SUBJECT: OPERATING CYCLE 11 RELOAD (TSCR 149, TAC 61863)

Re: Oyster Creek Nuclear Generating Station

AMENDMENT TO PROVISIONAL OPERATING LICENSE

Amendment No. 111  
License No. DPR-16

FIGURE 3.10-4  
 MAXIMUM ALLOWABLE AVERAGE PLANAR  
 LINEAR HEAT GENERATION RATE  
 (FIVE LOOP OPERATION)

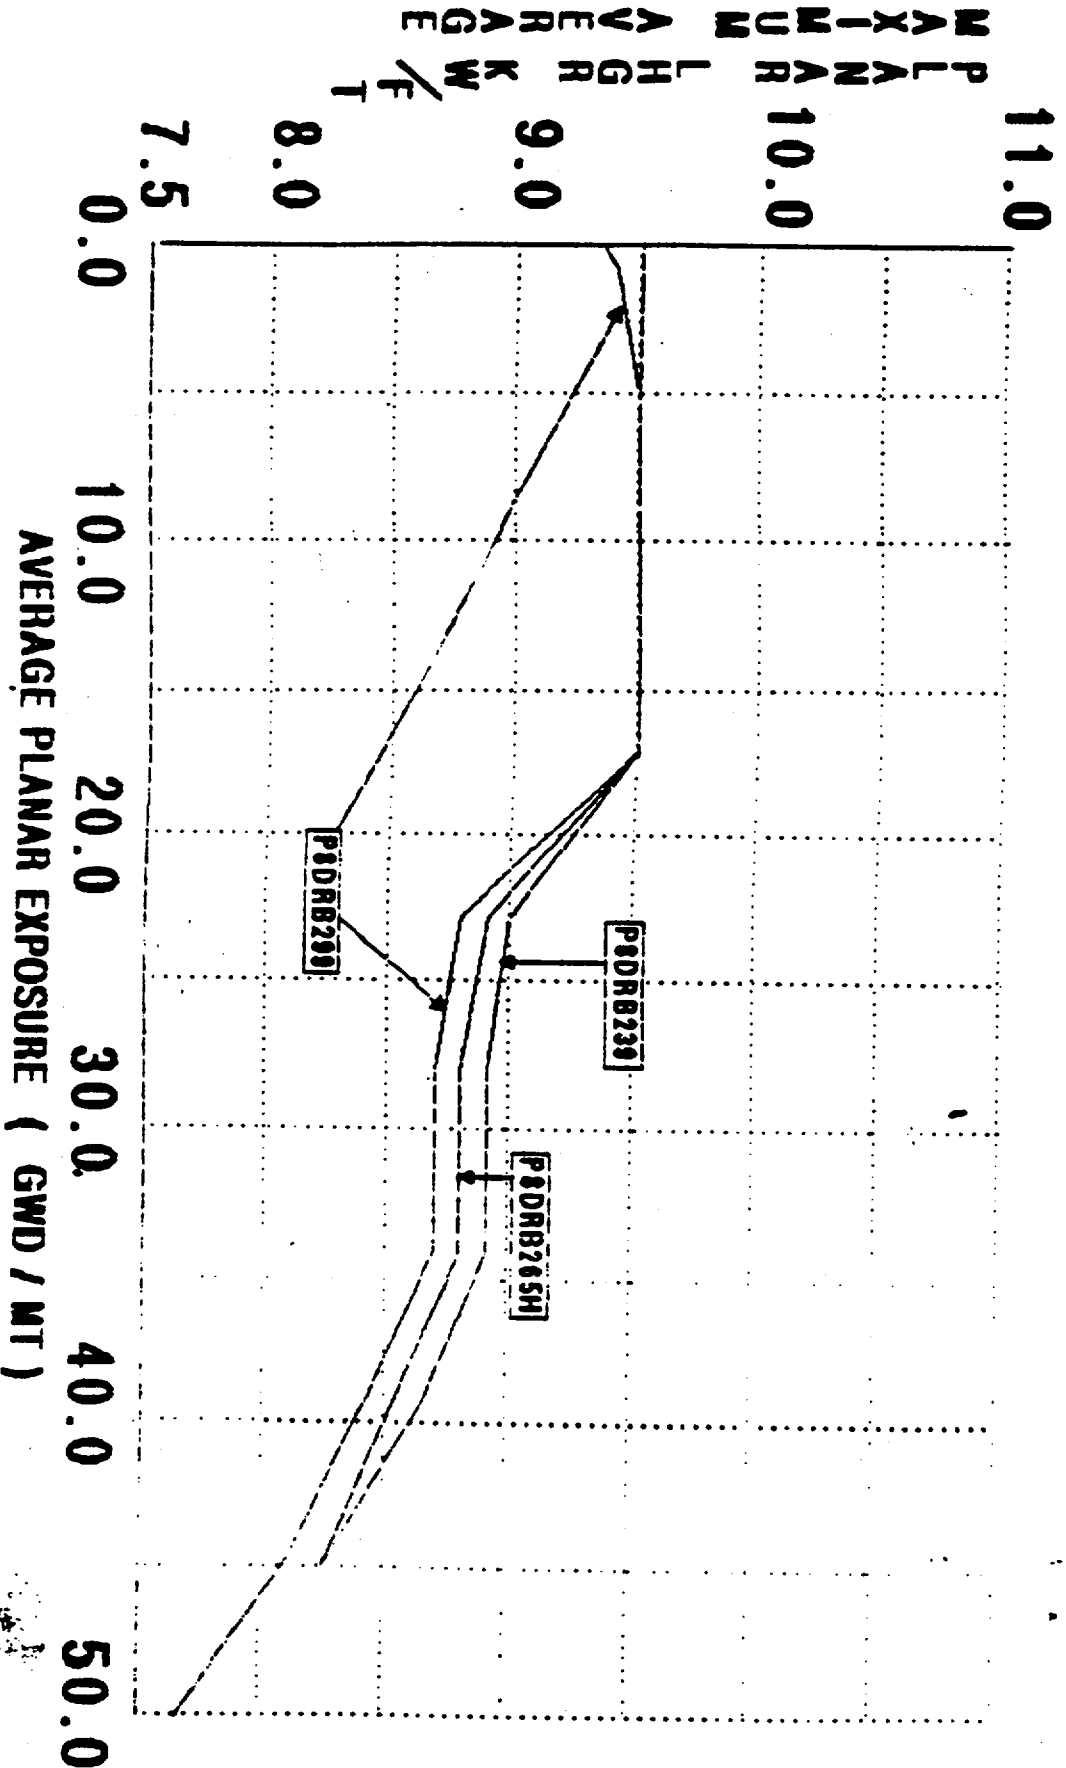
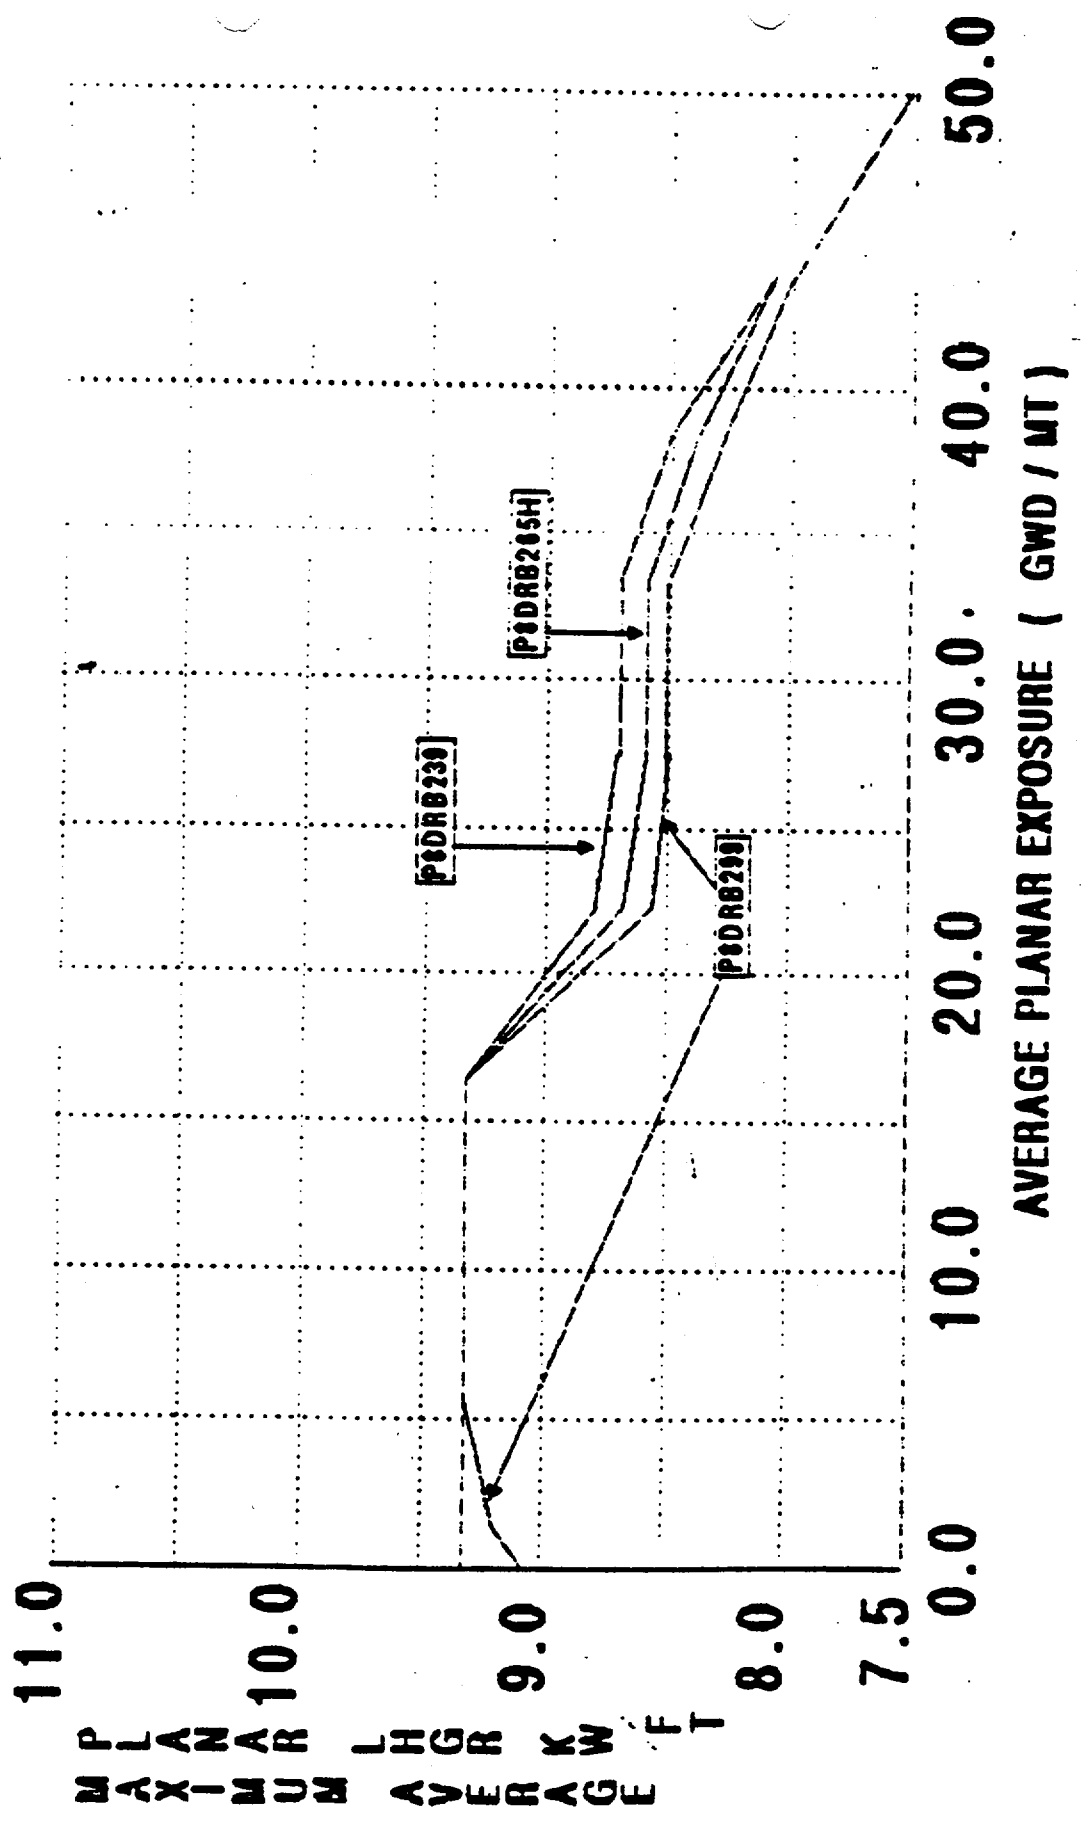
The licensee has proposed that two MAPLHGR curves for the fresh fuel bundles of P8DRB299 be added to the Oyster Creek Technical Specifications to replace a reference to the same curves in a proprietary General Electric Topical Report (Reference 4). This is an administrative change which we find to be acceptable and appropriate.

The MCPR Limits are revised from 1.40 to 1.45 and maximum allowable average planar LHGR curves for 5 and 4 loop operations as described in Appendix D of Reference 1 are added. The staff has reviewed the proposed TS changes for Cycle 11 and concludes that they are acceptable.
